# Nomad

# SERVICE BULLETIN

## INDICATION/RECORDING SYSTEM — AURAL WARNING UNIT — RELOCATION OF CIRCUIT BREAKERS (MOD N613)

Record compliance with Service Bulletin NMD-31-2 in the Airframe Log Book.

**Figure 1 Battery Circuit Breaker Panel (LH Pod)**

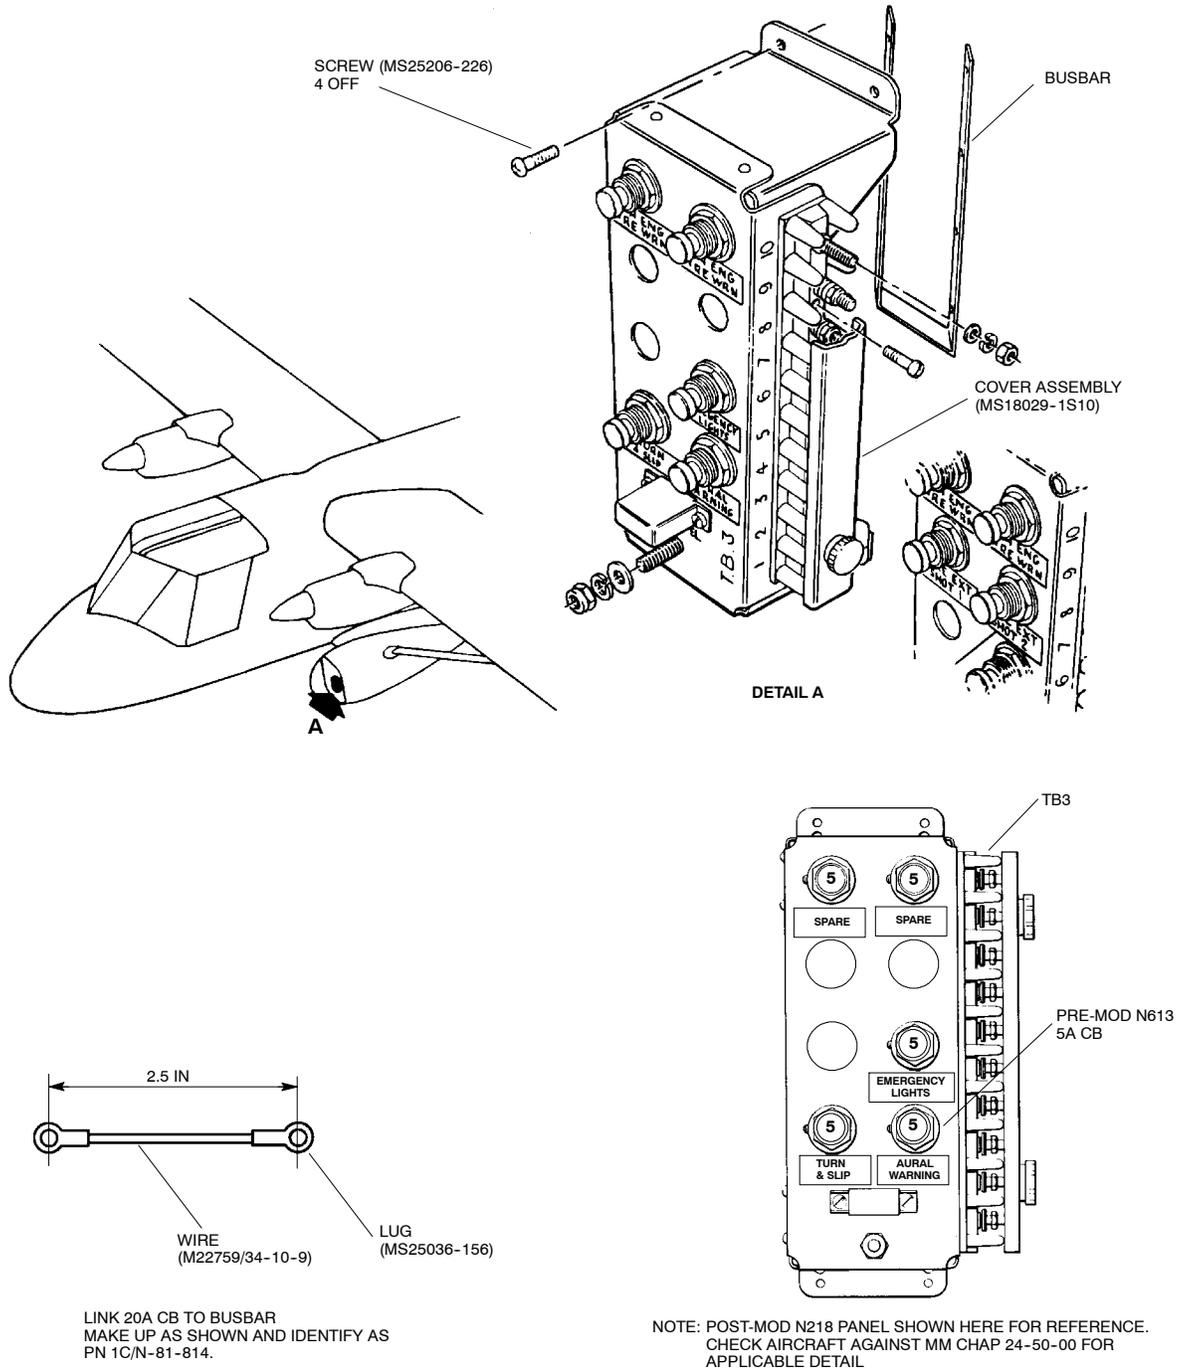
- (6) Remove and retain cover assembly (MS18029-1S10).
- (7) Disconnect and discard wire W15A22 (Ref WDM Chap 27-50-00, Sheet 2 Pre-Mod N613) between terminal 2 on TB3 and 5A circuit breaker labelled AURAL WARNING. Retain nuts and washers for re-use.

- (8) Remove and discard circuit breaker (MS22073-5).
- (9) Remove and discard wire W15B22 (Ref WDM Chap 27-50-00, Sheet 2, Pre-Mod N613) between terminal 2 on TB3 and GEAR+ terminal on the Aural Warning Unit on the cockpit bulkhead. Retain nuts and washers for re-use. Alternatively, this wire may be left in place with the lugs removed and the ends capped.

- (1) Install circuit breaker (MS24510-A-20) in the space vacated in step 2.A.(8) above.
- (2) Make link cable to busbar using wire (M22759/34-10-9), lugs (MS25036-156) as per Figure 1. Identify as 1C/N-81-814. Attach to busbar with screw (MS35206-242) and nut (MS21083N08) and to circuit breaker with screws provided.

Figure 2 Overhead Console Circuit Breaker Panel

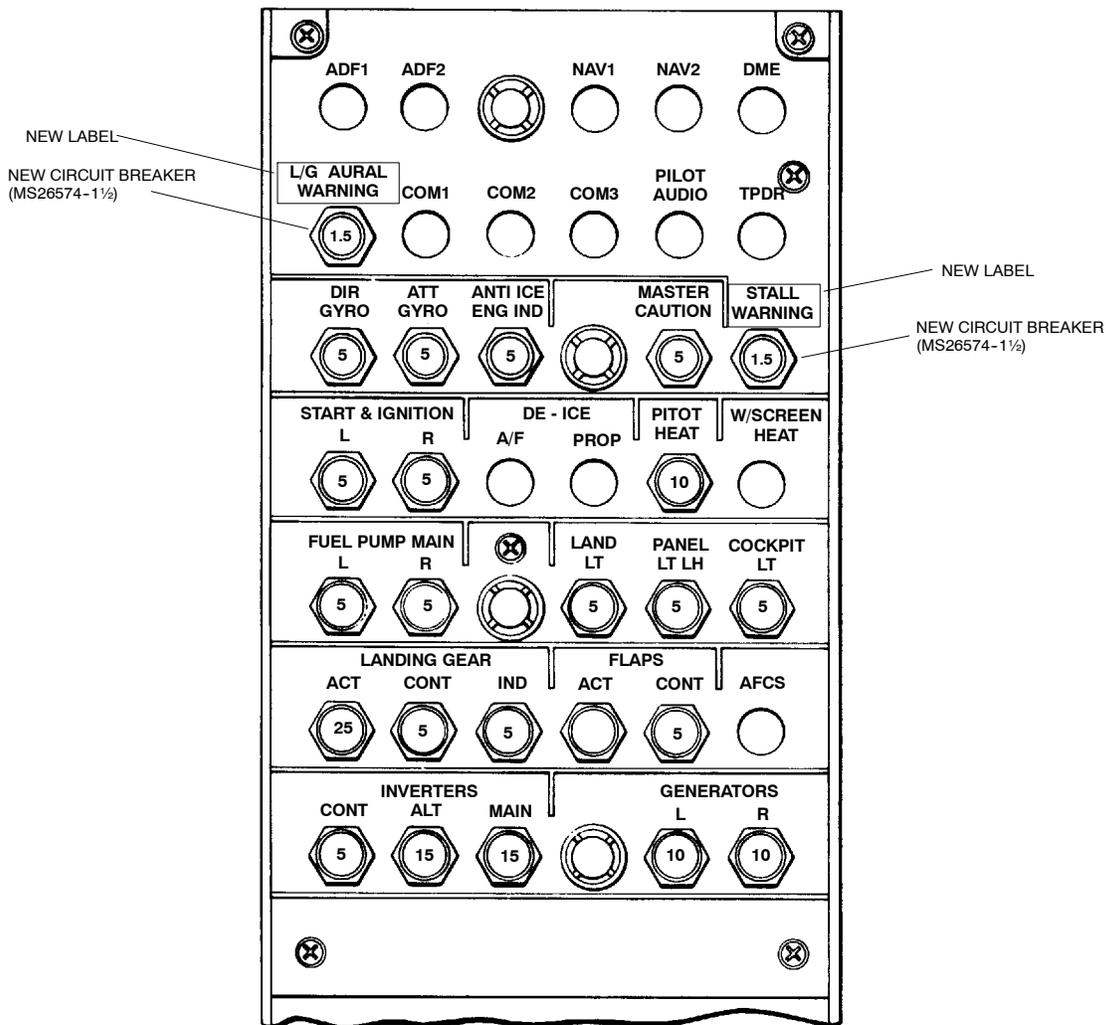
- (7) Fit new circuit breakers (MS26574-1½) in positions shown in Fig 2. Connect to busbar using supplied screws and washers.
- (8) Make up and fix labels as shown in Fig 2.
